INTER - OFFICE COMMUNICATION

**SUBJECT: Administrative Approval for Petition 2012-059 (SBG Properties, Inc. – Berewick Commons)**

Petition 2012-059

DATE	July 19, 2012 revised 6 Feb 2013
SCALE	As Noted
JOB NO.	20111544
SHEET	2/4

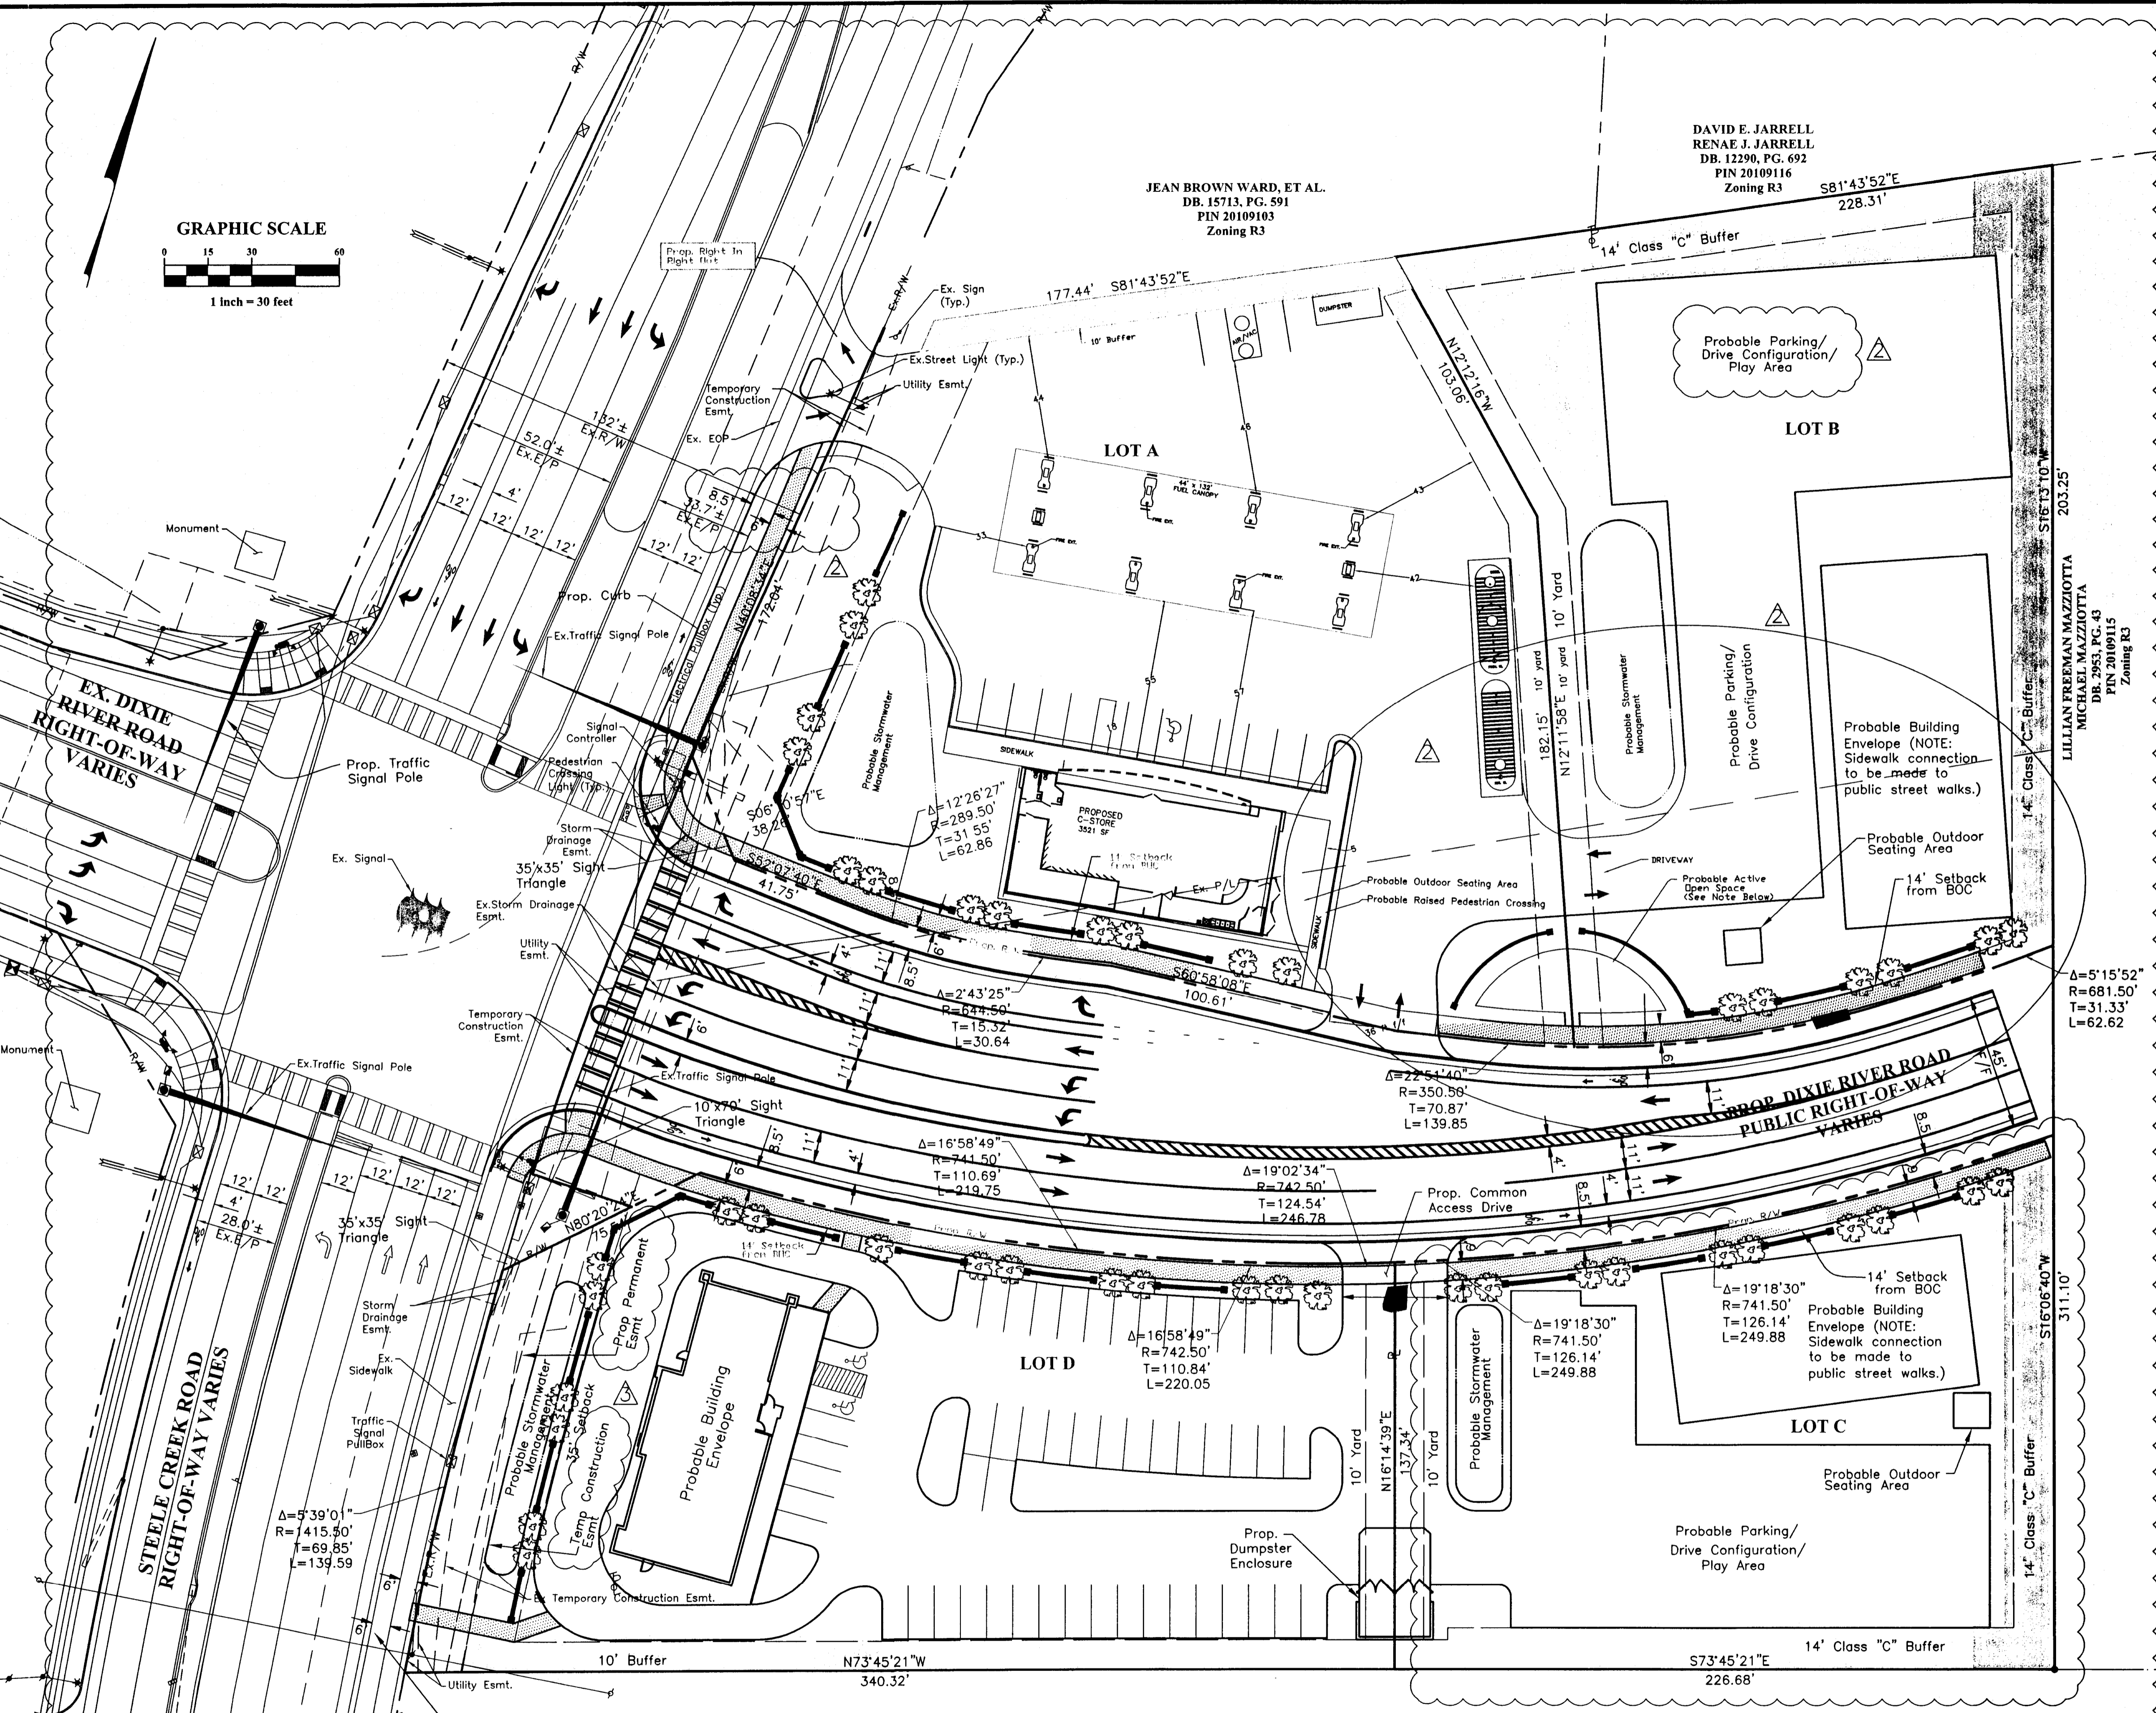
Attached are revised plans for the above petition. The site plan has been revised to modify the building layout for “Lot A” along with the building elevations for the proposed structure on that lot. No other modifications were made to the remaining three lots

Since these changes are minor and do not alter the intent of the development and meet the requirements of the Charlotte Zoning Ordinance Section 6.207 Alterations to Approval, I am administratively approving these plans. Please use these plans when evaluating requests for building permits and certificates of occupancy.
